Access Compliance Report

Public Rights-of-Way

| Intersection ID: 8721 | Main Street: LAUREN_ELIZABETH_CT | Cross Street: STONE_BLUFF_CT | Location: W |
| ADA ID: CA16009ACDF9 | Ramp Type: Perp | Initial Pass/Fail: Fail | Overall Compliance: No |

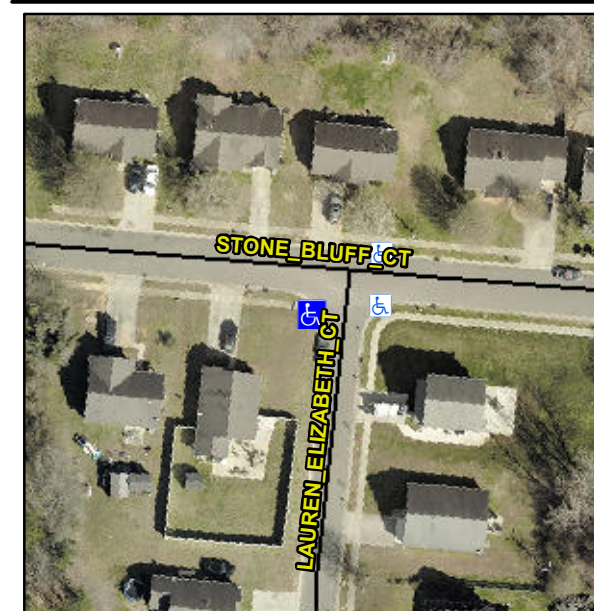
Not Found, R304.5.1

| Compliance | Description | Data | Compliance | Description | Data |
|------------|-----------------------|------|------------|-----------------------------|------|
| No | Ramp Width (in) | 47.5 | Yes | Ramp XSlope (%) | 1.3 |

Remove & Replace Entire Ramp.
